# ATtiny204/404

## ATtiny204/404 Silicon Errata and Data Sheet Clarification

**Figure 3-1. Block Diagram**

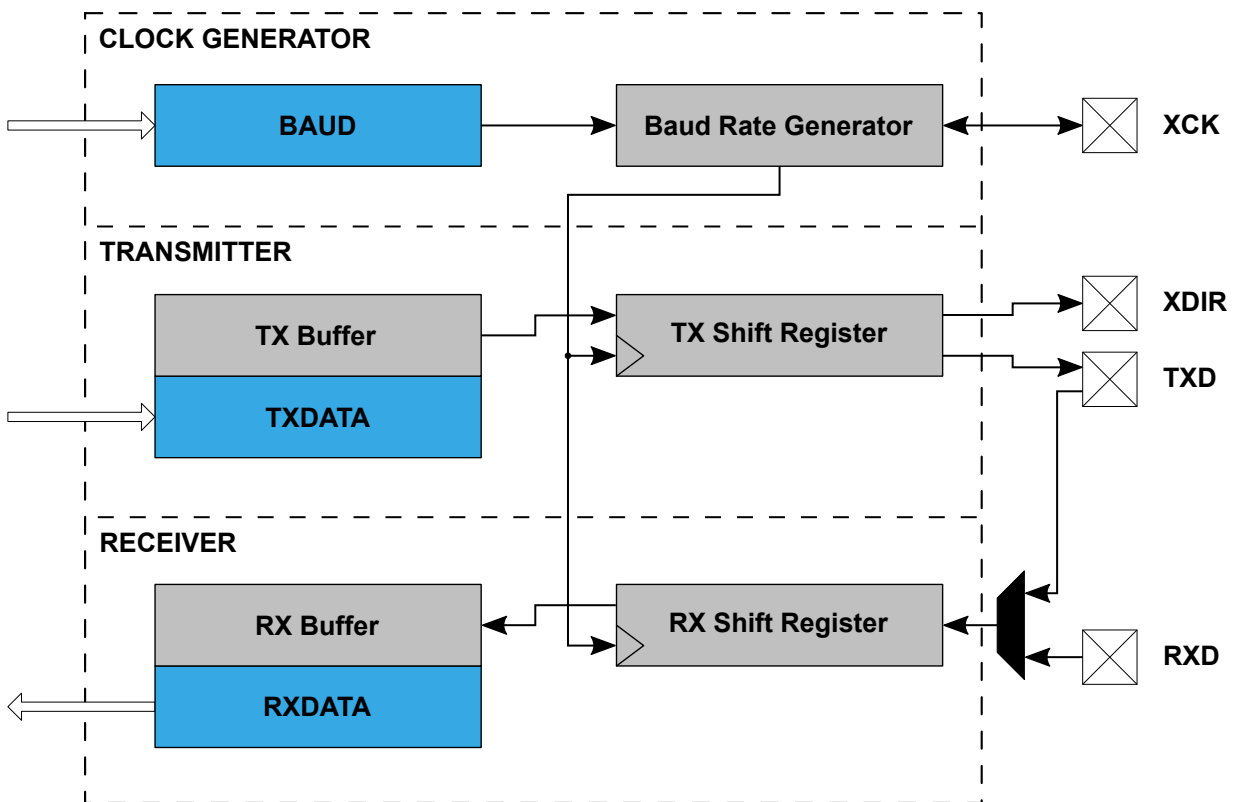
The block diagram is missing that USART TX is double-buffered from figure 25-1 in the data sheet. Added **TX Buffer** is shown below.

The transmitter consists of a **two-level** write buffer.

The data transmission is initiated by loading the **Transmit Data (USARTn.TXDATAL and USARTn.TXDATAH)** registers with the data to be sent. The data in the **Transmit Data registers are moved to the TX Buffer** once it is empty and onwards to the Shift register once it is empty and ready to send a new frame.
